American River Pump Station Project

**Final Environmental Impact Statement/
Environmental Impact Report**

**Appendix C - Volume 1
Responses to Comments on the
Draft Environmental Impact
Statement/Environmental Impact Report**

June 2002

Figure 3-2 Hydraulic Profile of Water Deliveries from the American River Pump Station

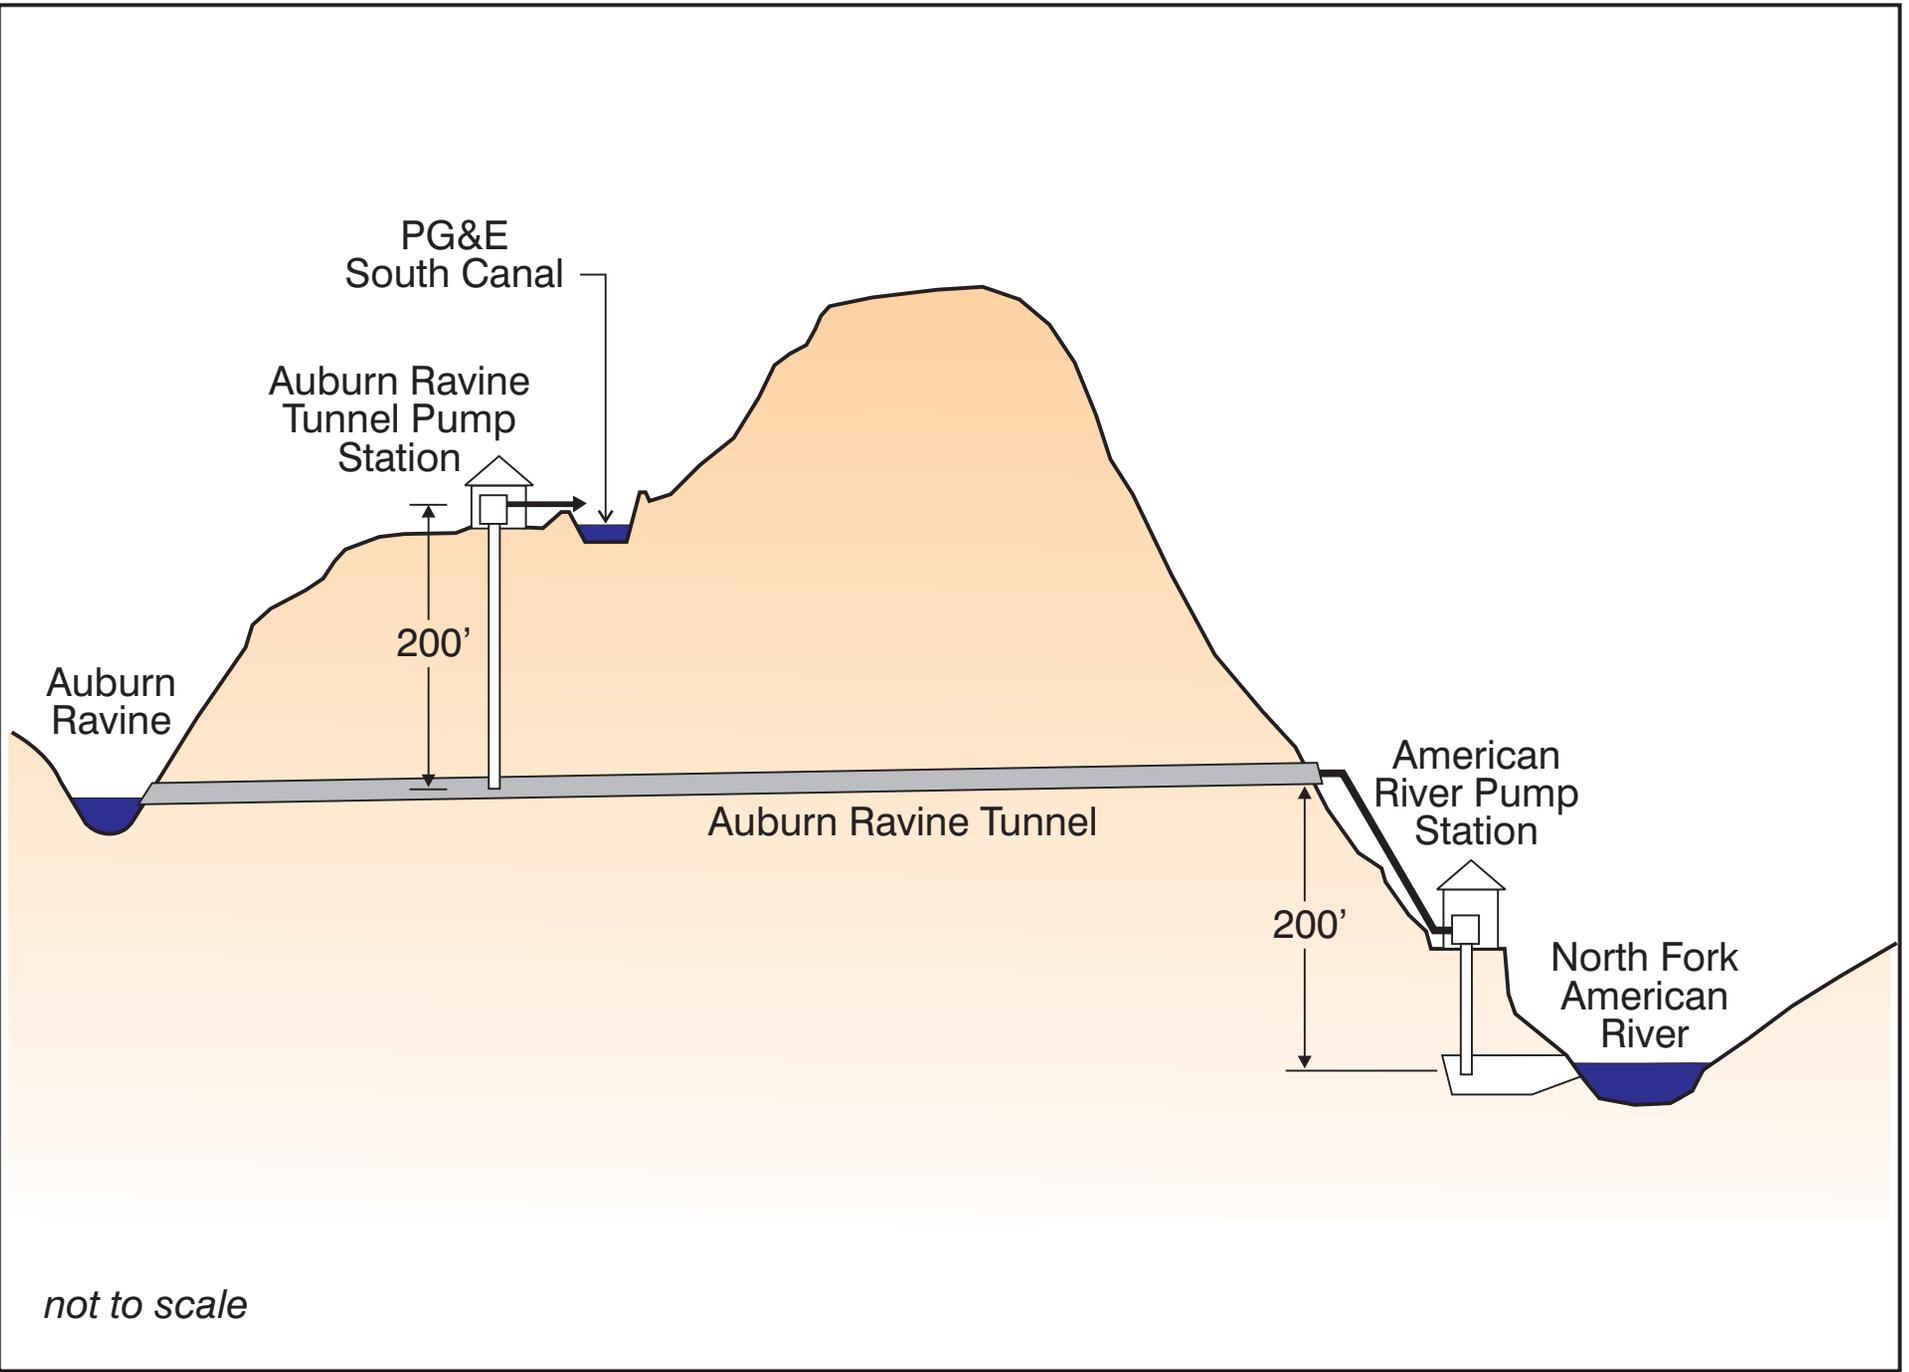
Summary of Public Comment Issues Related to Auburn Ravine

the Auburn Ravine Tunnel, and from the tunnel would be pumped again into PG&E's South Canal by the Auburn Ravine Tunnel Pump Station (**Figure 3-2**). The water would then flow within the South Canal where it would be delivered to the Foothill WTP (**Figures 3-3 and 3-4**). The formerly proposed American River water increase in Auburn Ravine therefore would be avoided; however, the American River water currently delivered to Auburn Ravine would remain within the limits of recent historical monthly maximum delivery rates.
